#### PLANNING AND ZONING BOARD STAFF REPORT

#### 314 NE 3rd Avenue

Meeting	File No.	Application Type
August 12, 2024	2024-081-SPF-SPR-LV4	Level 4 Site Plan with CBD Waiver
Applicant/Property Owner		Authorized Agent
Ocean Parker Delray, LLC		Jeffrey A. Costello, AICP, FRA-RA

Provide a recommendation to the City Commission on a waiver request associated with a Level 4 Site Plan for a mixed-use development, to reduce the front setback requirement from the required 10 feet to 6 feet.

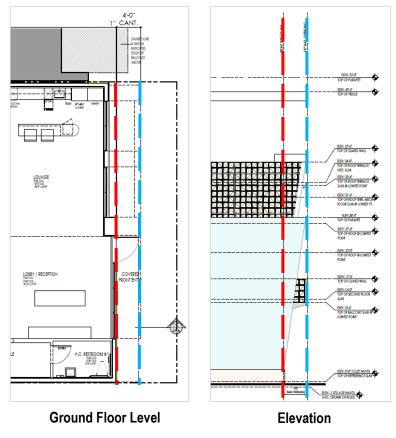
The request is to reduce the front setback from a minimum of 10 feet (red dashed) to six feet (blue dash). The ground floor level would meet the required 10-foot setback (image at right); however, the overall building mass angles out towards the streetscape and the second floor and the overhang above the rooftop encroaches four feet into the setback (far right image).

The applicant is requesting a reduction of the required front setback. The required minimum setback of ten feet would be reduced to approximately six feet. The ground floor of the building begins at the required setback of 10 feet and the entire front façade leans four feet into the front setback. The encroachment does not exceed into the pedestrian clear zone and curb zone; therefore, the pedestrian experience on the ground level will not be affected by the request. The proposed streetscape has been swapped to place the pedestrian clear zone adjacent NE 3<sup>rd</sup> Avenue and then the curb zone; this is proposed to meet the existing streetscape configuration on NE 3<sup>rd</sup> Avenue. The proposed streetscape meets the dimensional requirements in LDR Section 4.4.13(E)(2). The proposal depicts approximately six feet and four inches for the pedestrian clear zone corner and four feet for the curb zone.

Overall, in consideration of the waiver criteria, the request is not anticipated to diminish the pedestrian experience or the connectivity of the street and sidewalk network. The request is not anticipated to negatively affect the neighboring area or create unsafe conditions. Other projects with similar conditions have been granted approvals.
